# **HID Headlamp Housing Paint Bubble / Poor Appearance**

Category Vehicle Exterior

Section Lighting (ext) Market USA

YEAR(S)	MODEL(S)	ADDITIONAL INFORMATION
2011 – 2013	IS F, IS250, IS250C, IS350, IS350C

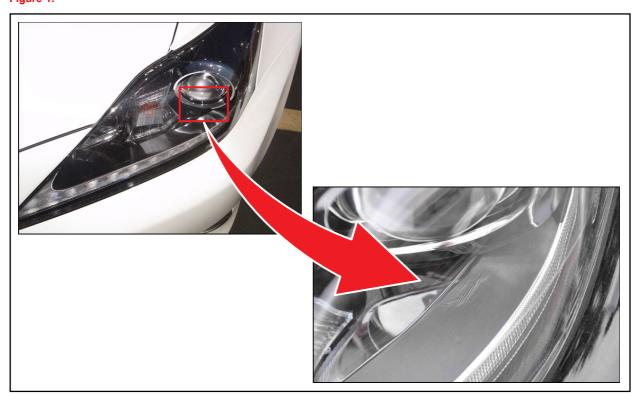
Confirm vehicle has the headlight housing paint bubble condition (see Figure 1 for an example).
If a poor appearance is found, continue to step 2. If not, this bulletin does NOT apply.
Figure 1.

- 2. Replace both headlight units.
  - A. Remove both headlights.
